From: Pelz, Susan
Sent: Monday, April 26, 2010 9:03 AM
To: 'Troy Hays'; Morris, John R.
Cc: Casey Stephens; Madden, Melissa; Morgan, Steve
Subject: RE: Citrus County Central Landfill LFG Remediation Near MW-10
Attachments: Citrus County Central Landfill LFG remediation.pdf

Re: Citrus County Central Landfill
Permit No. 21375-008-SO/01
Leachate treatment plant

730 NE WILCO ROAD, CANONVILLE, FLORIDA 32841 / (407) 327-4831	JONES EDMUNDS CENTRAL LANDFILL GROUNDWATER CONTAMINATION REMEDIATION CITRUS COUNTY, FLORIDA	SITE PLAN AND DETAILS
2615 S. STATE ROAD, APT. 118, TAMPA, FLORIDA 33606 / (813) 258-0793

DEEP SOIL VAPOR EXTRACTION SYSTEM DETAIL
NTS

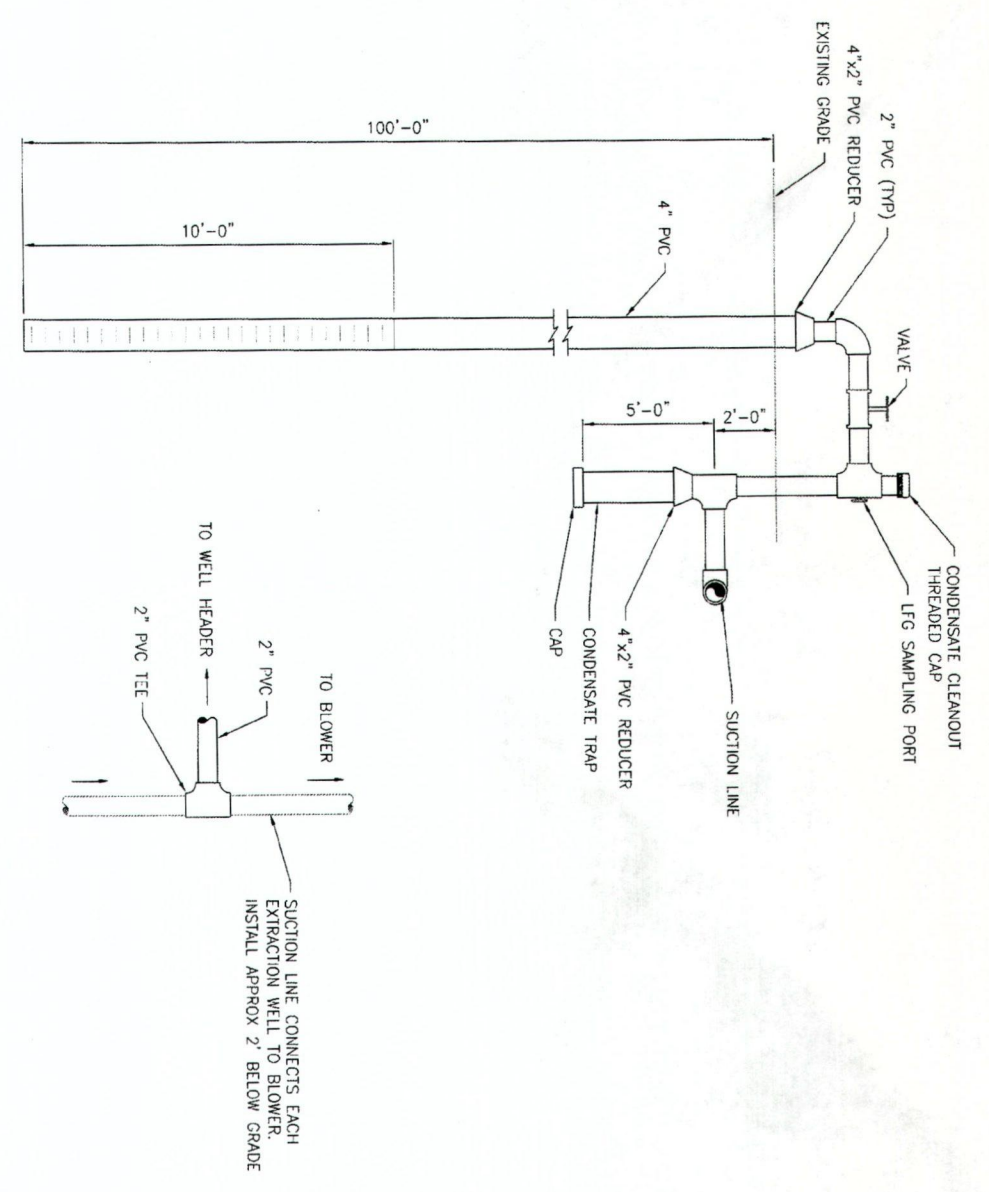
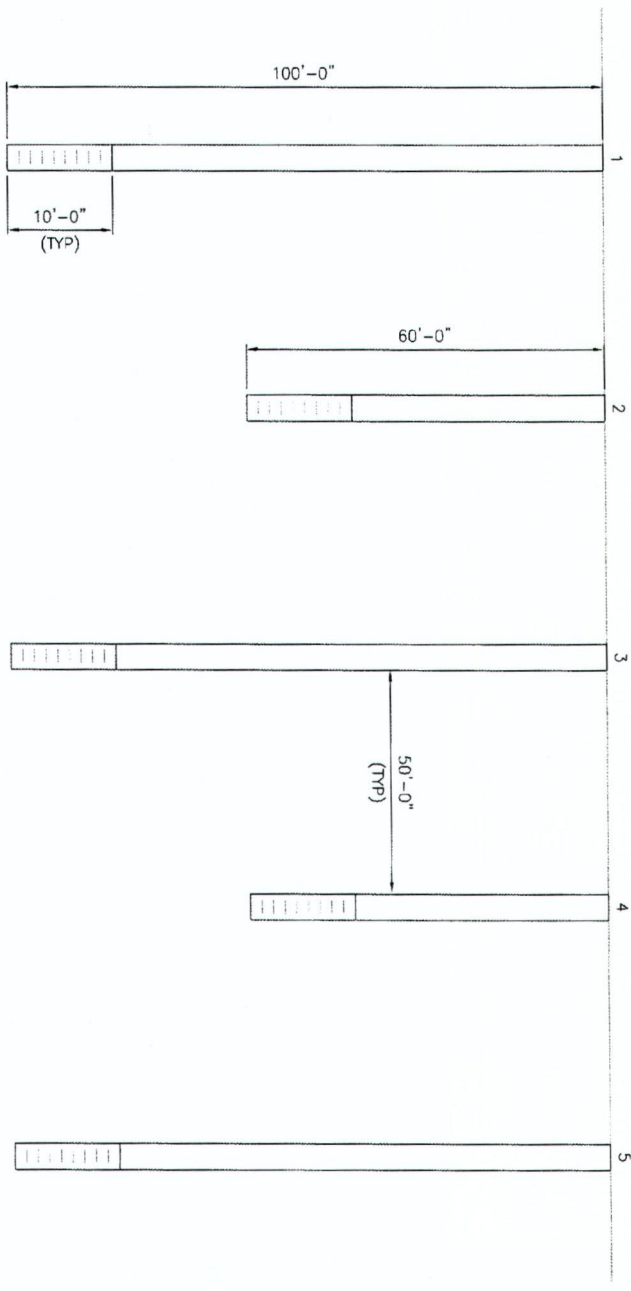
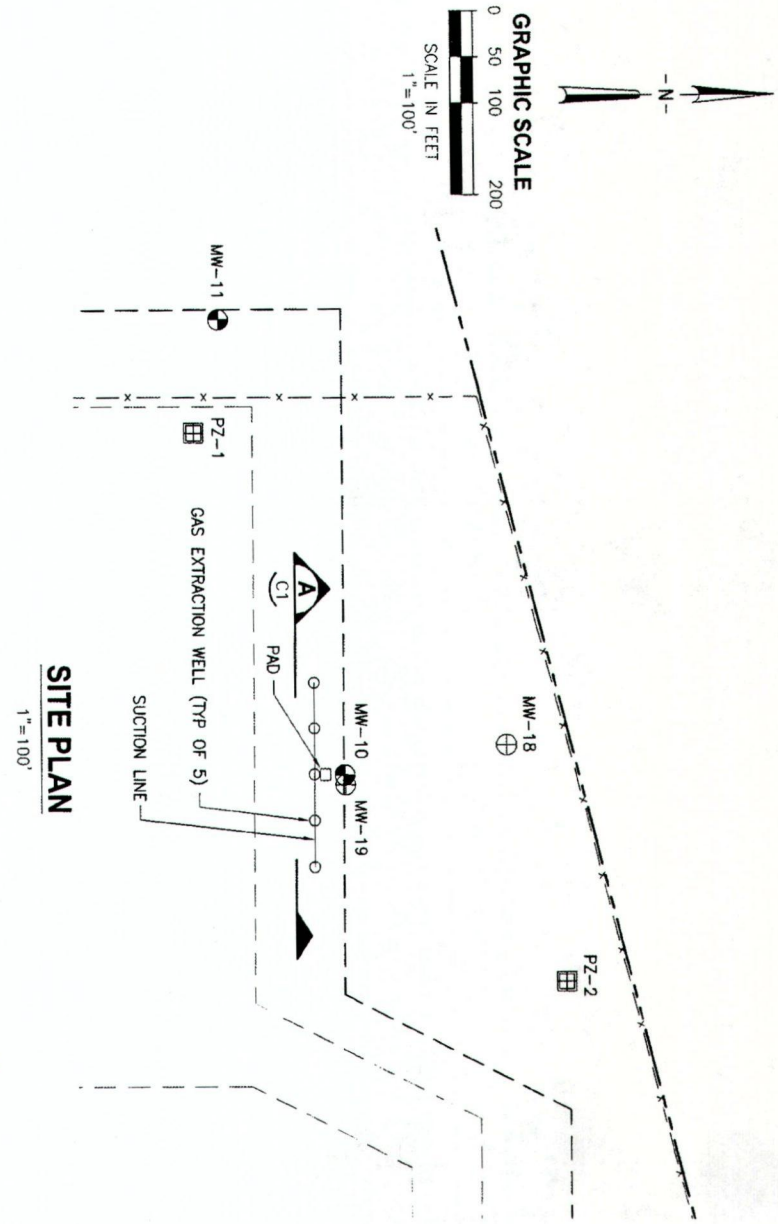
The updated drawings for the LFG remediation system near MW-10 at the Citrus Central Landfill are attached. The drawing of the solar electrical detail is unchanged. The drawing depicting the LFG extraction wells has been changed to include a detail of the below grade suction line connecting each of the wells to the blower and detail showing a vent stack coming out of the blower.

The Department **does not object** to the proposed corrective actions as described in the email below and its attachments.

DEEP SOIL VAPOR EXTRACTION SYSTEM DETAIL
 NTS

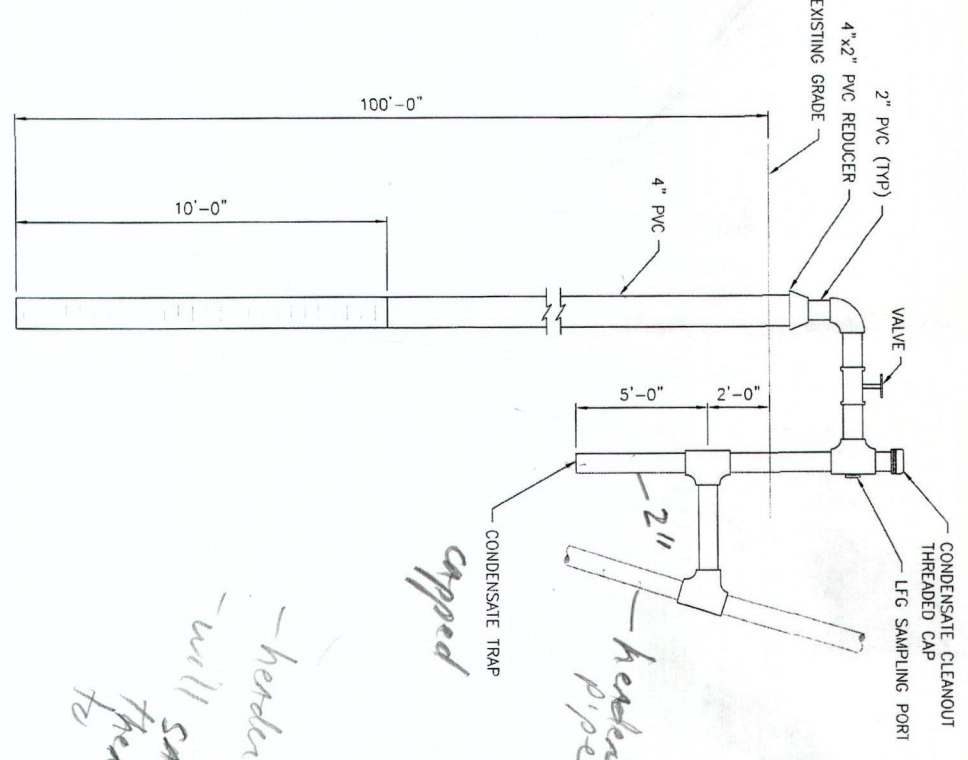
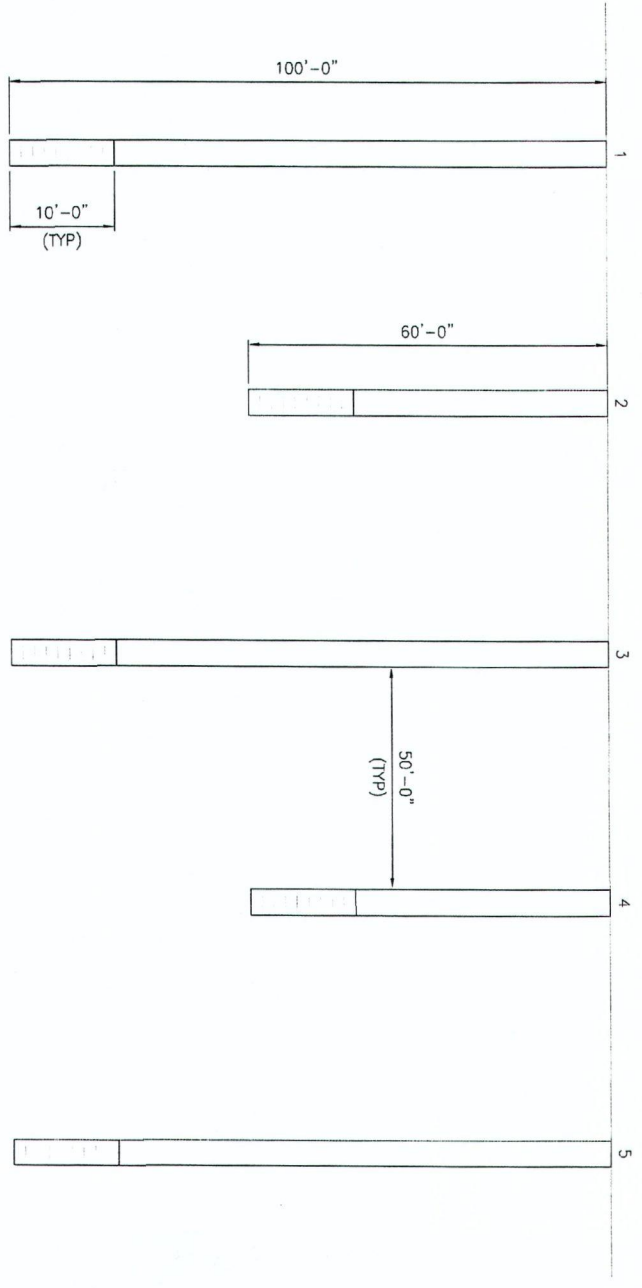
4/6/10 SJH/JAM
C1470 TELECOM W/ TROY HAYS
- ASKED FOR ADD'L DETAILS ON DRAWING C-1
- CONDENSATE TRAP IS CALLED
- HEADER PIPE WILL CONNECT THE 5 GAS WELLS TO THE BLOWER
- 1 SOLAR COLLECTOR & 1 BLOWER UNIT
- CONDENSATE TO BE CAPTURED OUT & MAINTAINED AS WASTEWATER; NOT SAMPLE CONDENSATE FOR ANALYSIS

*-header pipe to blower
 -will sample condensate to
 then pump/discharge to
 vent with tank
 capped*
